RESPONSE TO REQUEST FOR ADDITIONAL INFORMATION

APR1400 Design Certification

Docket No. 52-046

RAI No.: 210-8239
SRP Section: 08.03.01 – AC Power Systems (Onsite)
Application Section: 8.3.1
Date of RAI Issue: 09/14/2015

Figure 1. Cable tray arrangement(section view) in cable tray tunnel

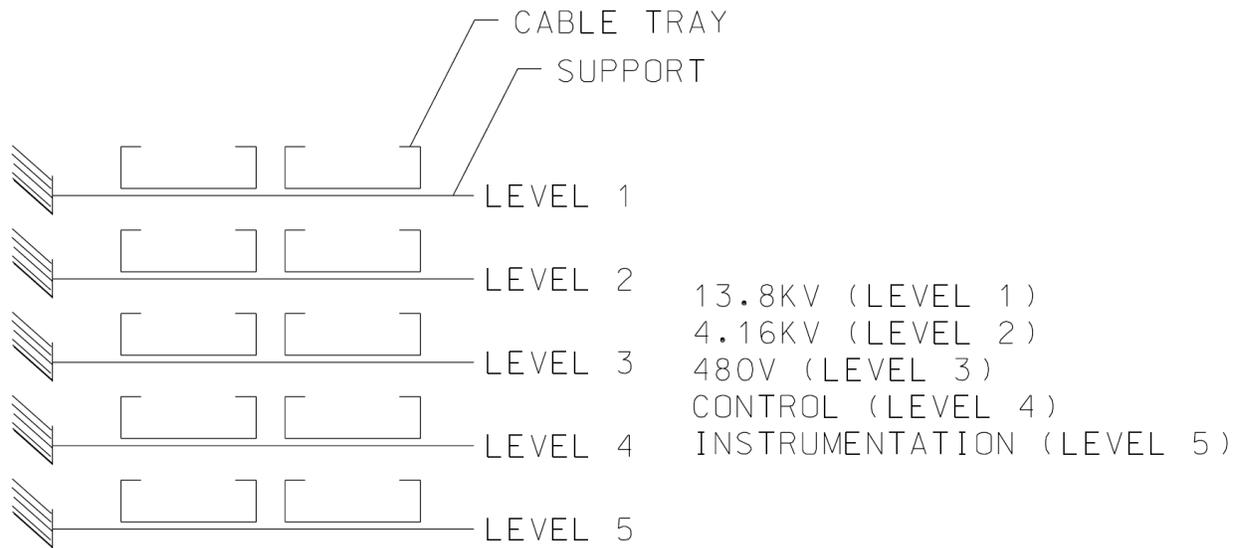
DCD Section 8.2.1.4 discusses the separation between the preferred power supply I and II. It discusses the cables that are routed from the SATs to the switchgears. The staff noted that the SAT LV side cables appear to be in a congested routing for connecting multiple secondary winding cables to the Class 1E and non-Class 1E switchgear. Please discuss how the APR1400 design addresses cable routing (through the trenches), cable spacing and separation, specifically when sharing safety-related cables of different voltage levels in raceways with non-safety-related cables, so that the design has capacity and capability to avoid unintended safety impact.

Cables from the SATs to the switchgears are routed in non-Class 1E cable trays through the cable tray tunnels, between SATs and building entries, and inside the turbine building or the auxiliary building.

Separate cable trays by voltage level (e.g., 13.8kV, 4.16kV, 480V, control, and instrumentation) are arranged typically in vertical direction with practical clearance between the cable trays. For each cable tray, appropriate cable spacing method is applied (e.g., maintained spacing for medium voltage cable trays and random fill spacing for low voltage, control and instrumentation cable trays). A typical layout (section view) of cable trays arrangement in the cable tray tunnel and a profile of maintained spacing of MV cables are provided in Attachment 1.

Since the cables from the SATs to the Class 1E switchgears are part of preferred power supply (PPS) circuits, they are non-Class 1E (non-safety related) and no separation requirements is imposed for the cables with other non-Class 1E cables.
